DEPARTMENT OF HIGHWAYS - ONTARIO			
MATERIALS & TESTING DIVISION - FOUNDATION SECTION			
DEVELOPMENT ROAD 724			
STA. 39 + 00 TO STA. 42 + 00			
KING'S HIGHWAY NO. _____		DIST. NO. 2 _____	
CO. MIDDLESEX			
TWP. W. WILLIAMS & ADELAIDE LOT _____		CON. _____	
BORE HOLE LOCATIONS & SOIL STRATA			
SUBWD. A B	CHECKED <i>19</i>	W.P. NO. _____	M.S.T. DRAWING NO. _____
DRAWN S.O.	CHECKED _____	JOB NO. 67 - F - 95-1	67 - F - 95 B.
DATE 18 JUL 1968	SITE NO. _____	BRIDGE DRAWING NO. _____	
APPROVED <i>A. B. Thomas</i>	CONT. NO. _____

SUPPLEMENTARY REPORT ON THE SOILS  
INVESTIGATION AT THE FAILURE AREA

On Development Road #724  
Sta. 39+00 to Sta. 42+00  
County of Middlesex  
W.J. 67-P-95-1 -- Dist. #2 (London)

Repairs to Development Road #724  
W.J. 67-F-25 -- District #2 (London)

FIG. 1

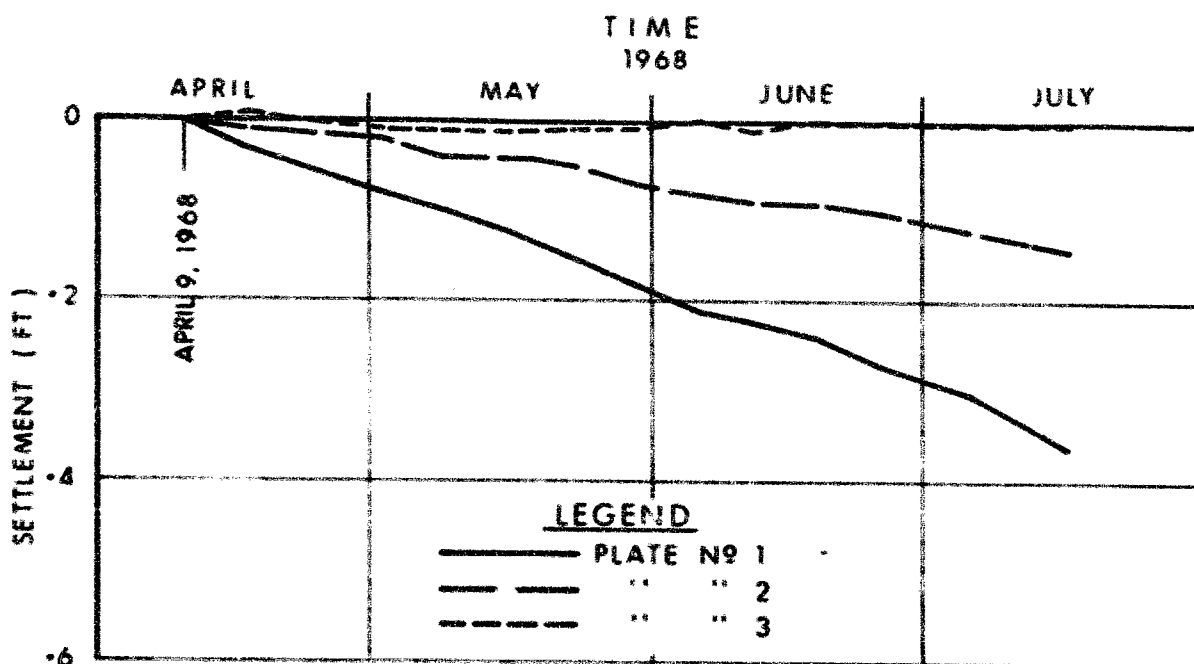
The settlement plates have been installed and observed now by the District for a period of 14 weeks. The locations of the plates and the observations of settlements are plotted on Figures #1 and #2. By the end of May 1968, it became obvious that the settlements at the approx. centre of the failure area (Plate #1) proceeded at a constant rate, averaging about  $3/16"$  -  $1/4"$  per week. Due to the fast rate of settlement, it was decided that further field investigation and instrumentation be implemented in order to present some remedial measures at an early date.

FIG. 3

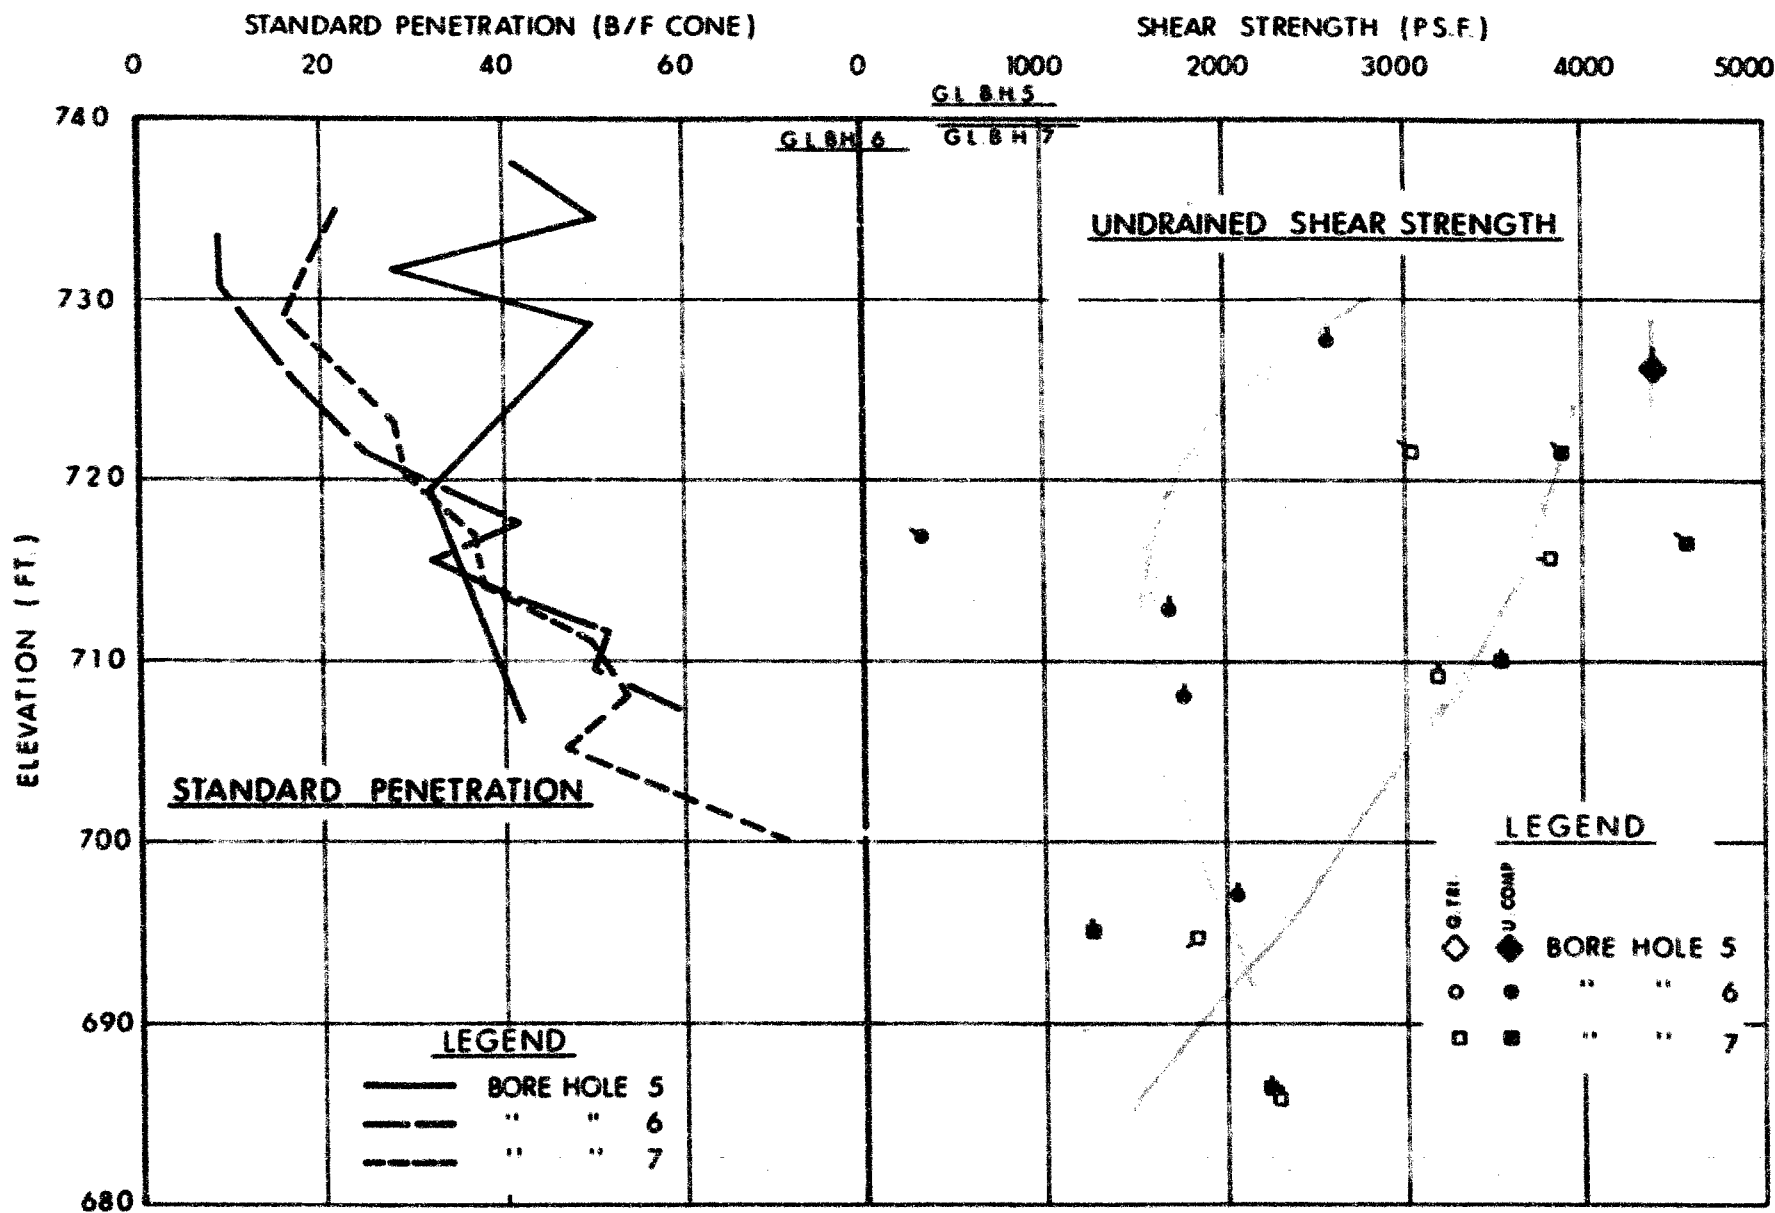
Various physical properties of the soil samples of B.H.'s #5, 6 and 7 were studied in order to compare the soils within the sound and within the failing area. B.H.'s #5 and #7 were assumed to lie within the relatively sound section, whereas B.H. #6 was placed on the approx. centre of the failure. Drawing #67-P-95C shows cross sections at or near above boreholes. On Figures #3 to 6 inclusive, there are graphical presentations of

certain physical properties of the samples. By examining the graphs it may be noted, that the values of the standard penetration tests are lower at the centre of the failure than at the sound zones. The weaker layer extends to approx. 20 ft. below shoulder level, corresponding to the depth of the new fill (Fig. #3). By comparing the undrained shear strength values, the difference appears to be even more pronounced. The upper approx. 40 ft. of material exhibits shear strengths lower in B.H. #6 than in B.H.'s #5 and 7. The 40 ft. includes the old dumped fill as well, indicating that this material, however dense it is, shows a great deal of disturbance and remoulding. On Fig. #5, a comparison is made of the liquidity indices. From the figure it is postulated that certain layers within the failure zone are wet, likely being caused by percolating groundwater. (See Fig. #5 - Elevation above 731 ft. again around El. 716 ft. and 697 ft.)

FIG. 6

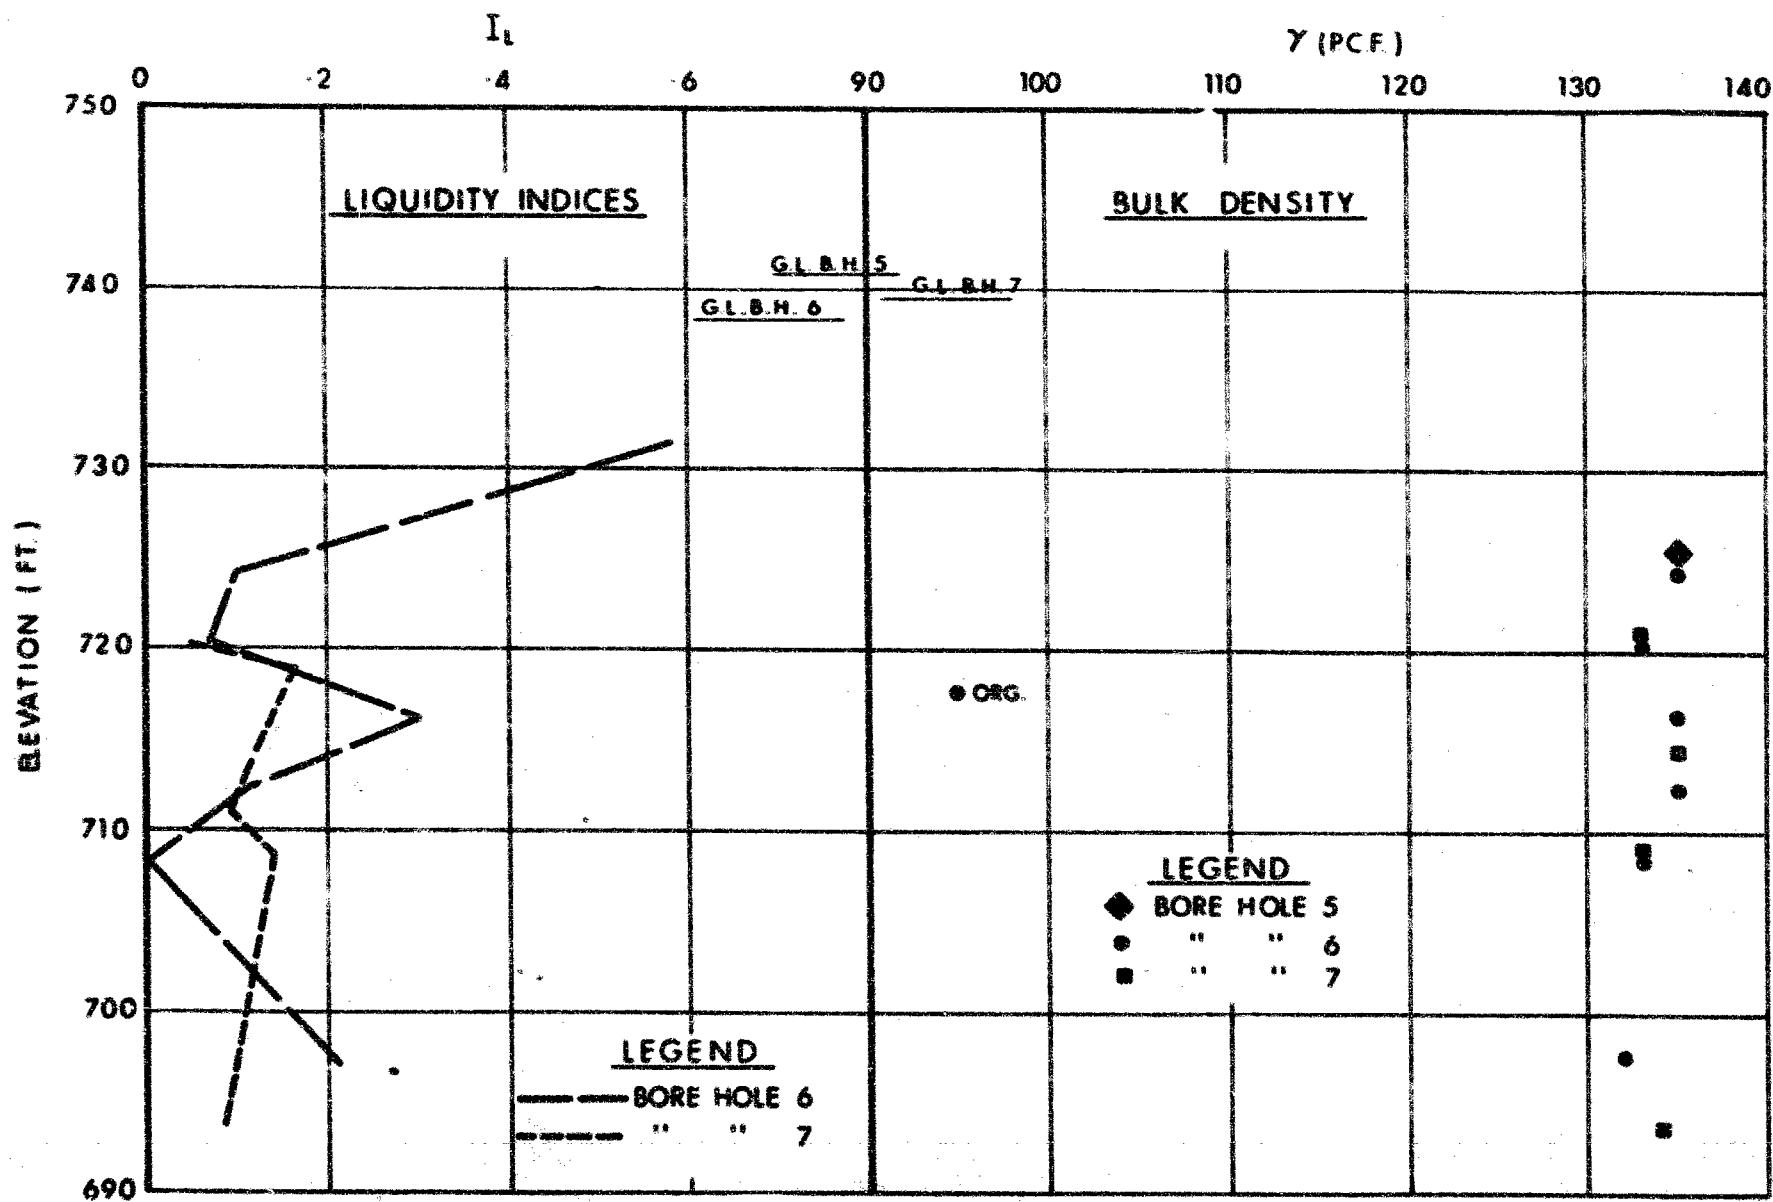
No variations of the bulk densities were noticed (Fig. #6) within the sound and the failing sections, suggesting that it is the disturbance of the soil structure rather than the overall density which can cause larger settlements. It has been published by investigators (Rutledge, 1944, Schmertmann, 1953) that sample disturbance decreases the void ratio at which the soil will carry any given vertical stress. The void ratio log pressure curve of a disturbed or remoulded sample is displaced downwards; however, the initial void ratio ( $e_0$ ) of the undisturbed and remoulded samples may be very similar.

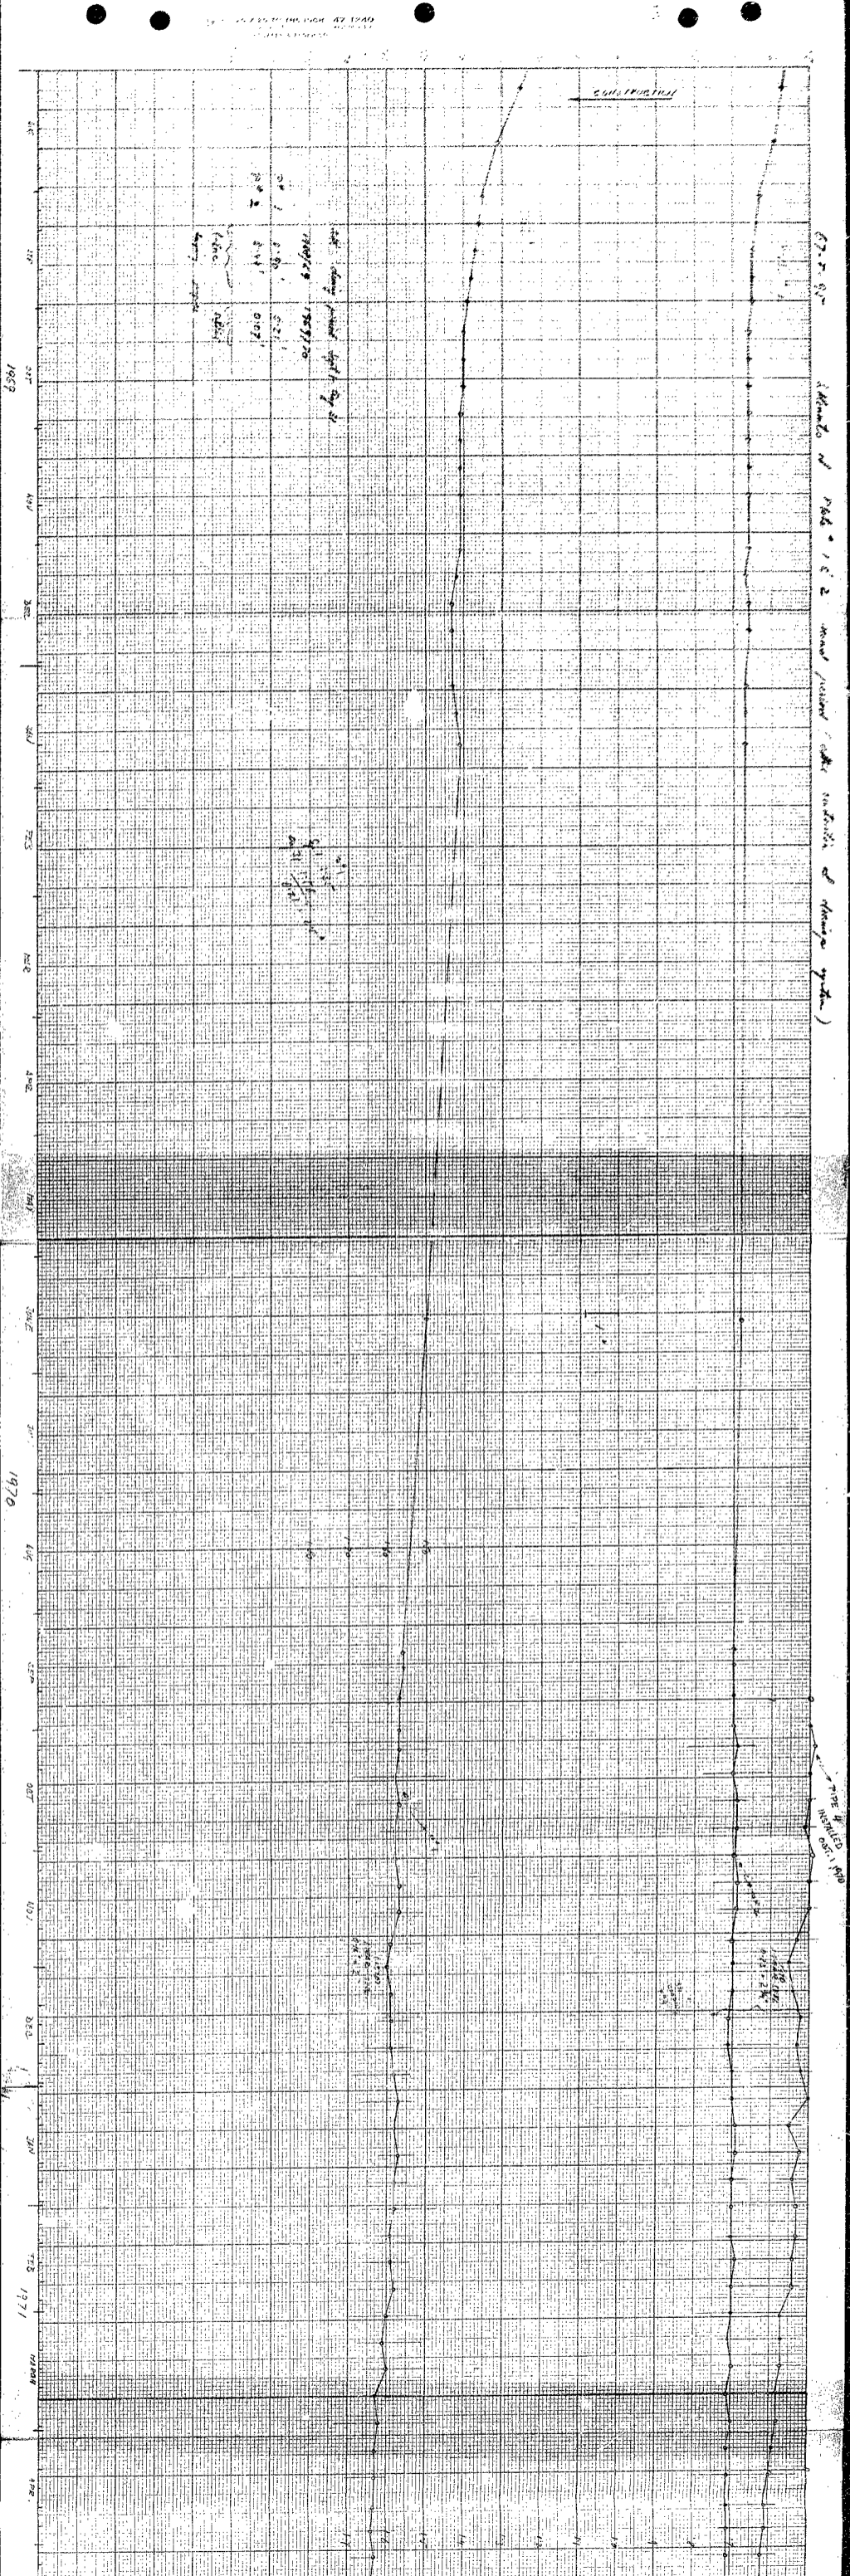
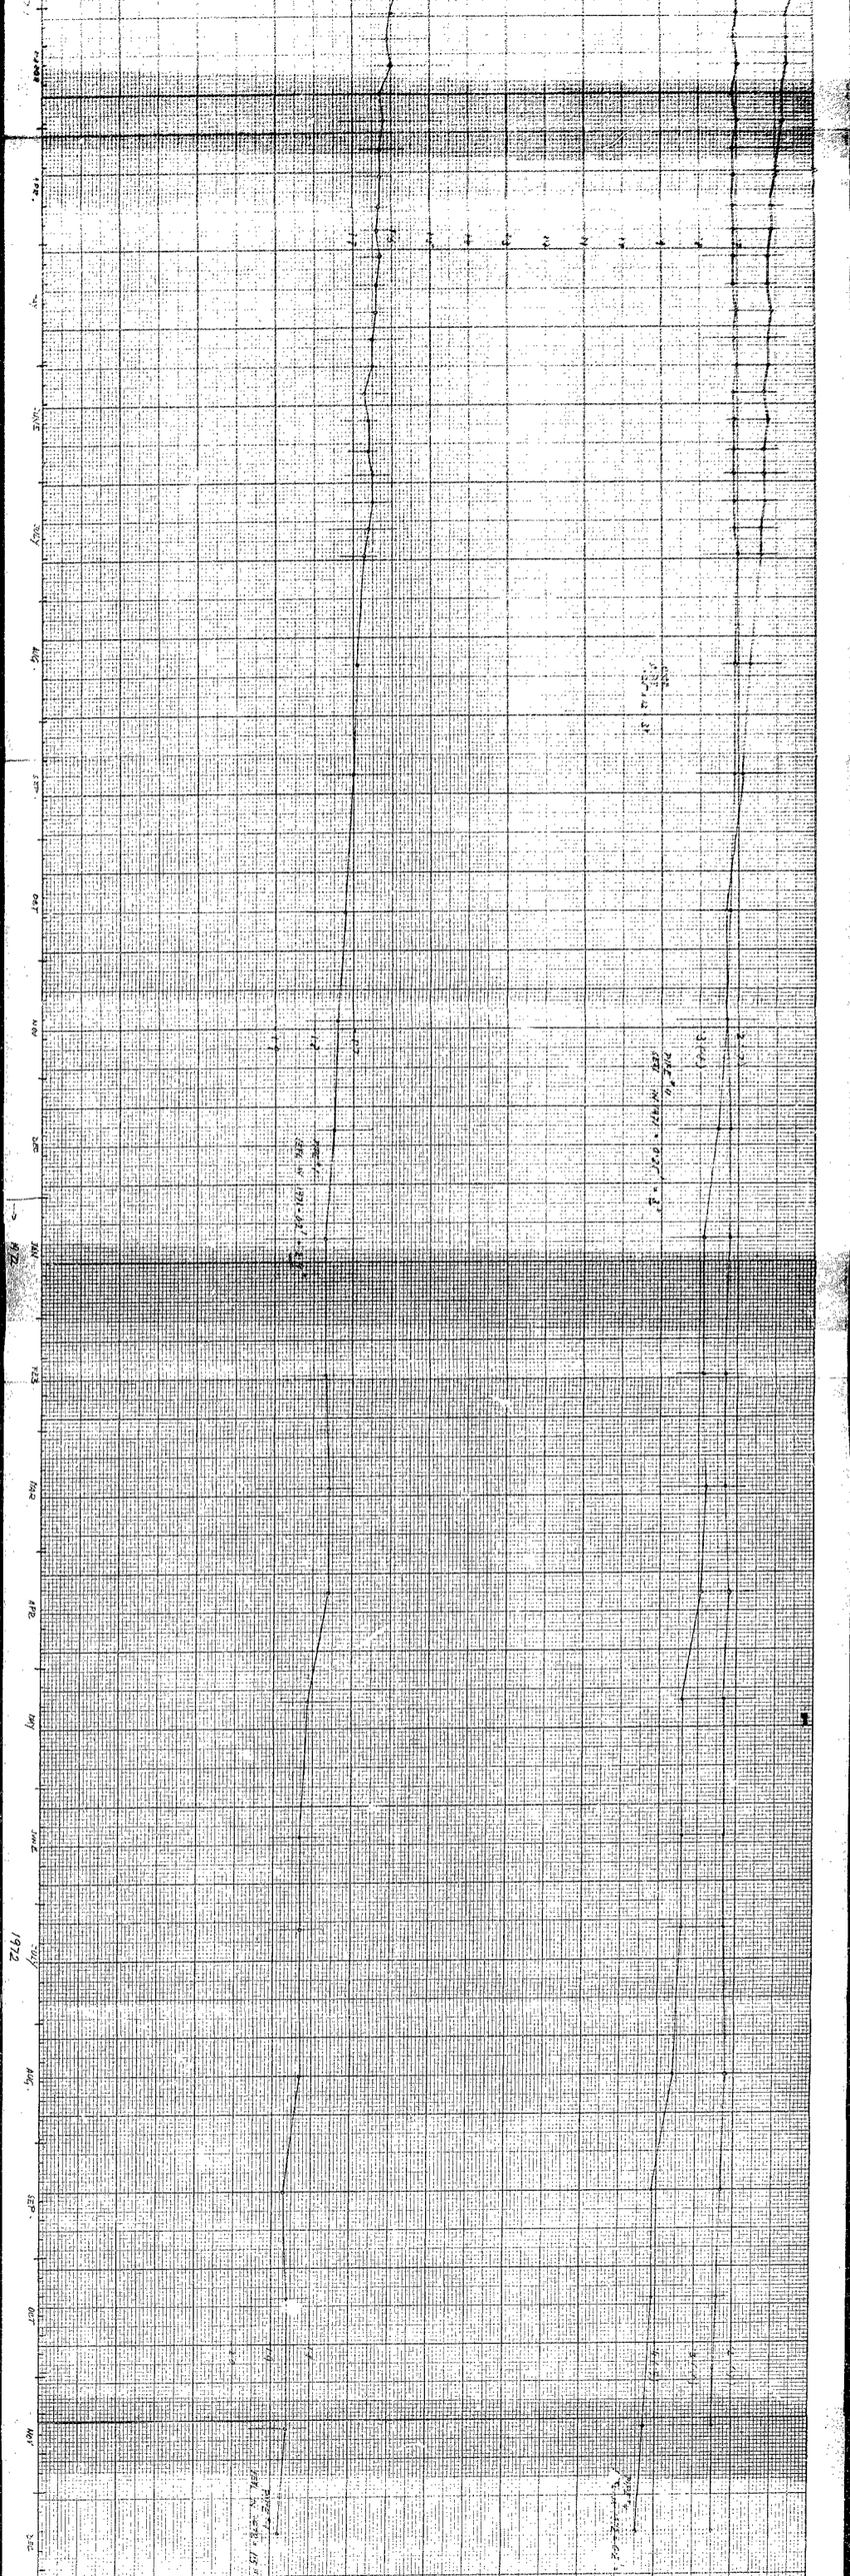
Plate # 1. It appears 39+90 and not 37+90 as indicated  
 on drawing. This is approx middle of failure and approx 50'  
 east of our bridge!

Small seepage along the length of north slope

38+40 have slope surface failure with seepage  
 intercepting drain works but not adequate. Either deeper  
 intercepting drain or counterfoot drains should be necessary.  
 Depth of granular no more than 3' at middle of  
 failure!
